Access Compliance Report

Public Rights-of-Way

Intersection ID: 10037061	Main Street: S_TRYON_ST	Cross Street: N/A	Location: SE
ADA ID: 9003D14F6838	Ramp Type: BlendTrans2	Initial Pass/Fail: Fail	Overall Compliance: No
		Severity Score: 12.5	
Codes/Mitigation Info/Possible Solution		Field Measurements/Component Compliance

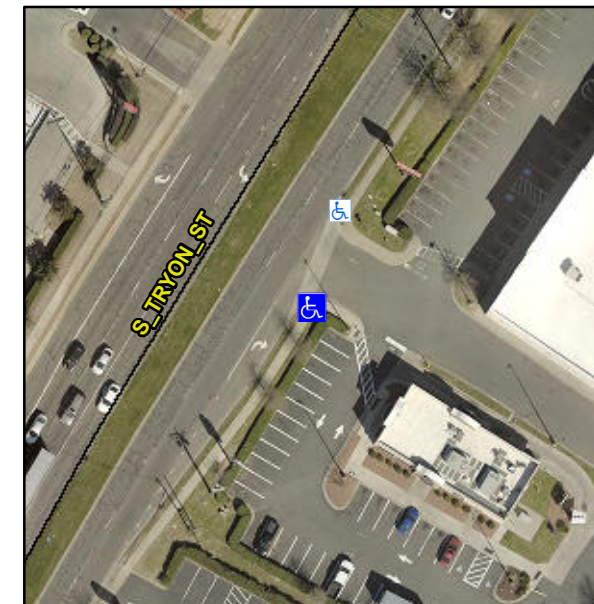
Not Found, R304.5.3

Compliance	Description	Data	Compliance	Description	Data
N/A	Ramp Length (in)	76.0	Yes	BlendTrans Slope (%)	2.2
Yes	Ramp Width (in)	48.0	No	BlendTrans XSlope (%)	6.1
N/A	Flare Type LT	N/A	N/A	Flare Type RT	N/A
N/A	Flare Slope LT (%)	N/A	N/A	Flare Slope RT (%)	N/A
N/A	Flare Traversable LT?	N/A	N/A	Flare Traversable RT?	N/A
N/A	Landing Length (in)	N/A	N/A	DWS Provided?	N/A
N/A	Landing Width (in)	N/A	N/A	DWS Contrast?	N/A
N/A	Landing Slope (%)	N/A	N/A	DWS Length (in)	N/A
N/A	Landing X Slope (%)	N/A	N/A	DWS Full Width?	N/A
N/A	Landing Curb? (Y/N)	N/A	N/A	DWS Offset (in)	N/A
N/A	Shared Landing?	N/A			
N/A	Gutter Ponding?	N/A	N/A	Gutter Slope (%)	N/A
N/A	Gutter Lip Ht (in)	N/A	N/A	Gutter X Slope (%)	N/A
N/A	Painted X Walk1?	No	N/A	Painted X Walk2?	N/A
	X Walk 1 Direction	To NE		X Walk 2 Direction	N/A
	X Walk 1 Width (in)	N/A		X Walk 2 Width (in)	N/A
	X Walk 1 Slope (%)	1.0		X Walk 2 Slope (%)	N/A
	X Walk 1 X Slope (%)	0.7		X Walk 2 X Slope (%)	N/A

N/A	Ramp inside XWalk1?	N/A	N/A	Ramp inside XWalk2?	N/A
	Road Slope (%)	0.7		Clear Space?	N/A
	Road X Slope (%)	1.0	N/A	Clear Space to XWalk (in)	N/A
N/A	Any Obstructions?	N/A	N/A	Storm Grate/Utility Hazard?	N/A
	Obstruction Type			Storm Grate/Utility Type	
		N/A			N/A
			Yes	Surface Condition? (G/P)	Good
			No	Curb Slope (%)	7.1

Remove & Replace Curb Ramp With Two New Directional Ramps or Equivalent.
